**Subject: Recall Campaigns P6 (06V-470) and P7 (06V-472)**

Subject: Safety Recalls P6 and P7

# Safety Recall Circular

**Inspect Wiper Motor and, If Necessary,  
Install Wiper Motor Cover Kit**

## Section D - Wiper Motor Cover Kit Installation

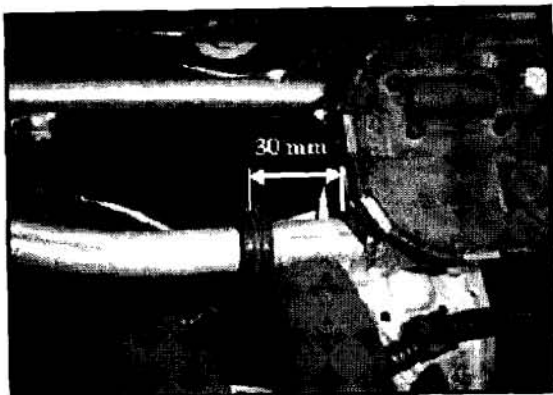
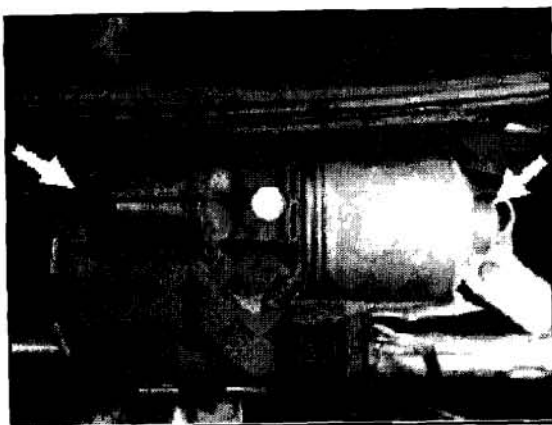
⇐ Cut rubber grommet on one side and slide it onto wiper motor support pipe about 30mm (1.18 in.) away from wiper motor - arrow-

- Secure rubber grommet using cable tie supplied in kit

Note: Lock portion of cable tie must be positioned towards firewall

⇐ Slide wiper motor cover over left tab on wiper motor -left arrow-, then slide other side of wiper motor cover over wiper motor end -right arrow-

⇐ After wiper motor cover has been installed, edge of cover should align with rubber grommet -arrow-

## Section D - Wiper Motor Cover Kit Installation

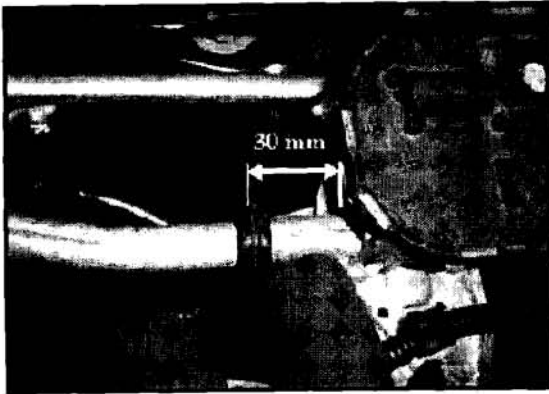
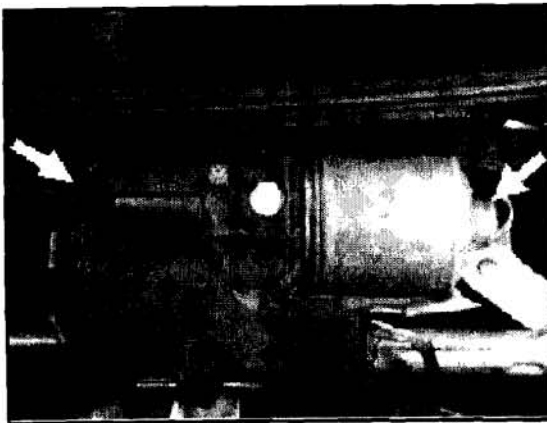
⇐ Cut rubber grommet on one side and slide it onto wiper motor support pipe about 30mm (1.18 in.) away from wiper motor - arrow-

- Secure rubber grommet using cable tie supplied in kit

Note: Lock portion of cable tie must be positioned towards firewall

⇐ Slide wiper motor cover over left tab on wiper motor -left arrow-, then slide other side of wiper motor cover over wiper motor end -right arrow-

⇐ After wiper motor cover has been installed, edge of cover should align with rubber grommet -arrow-
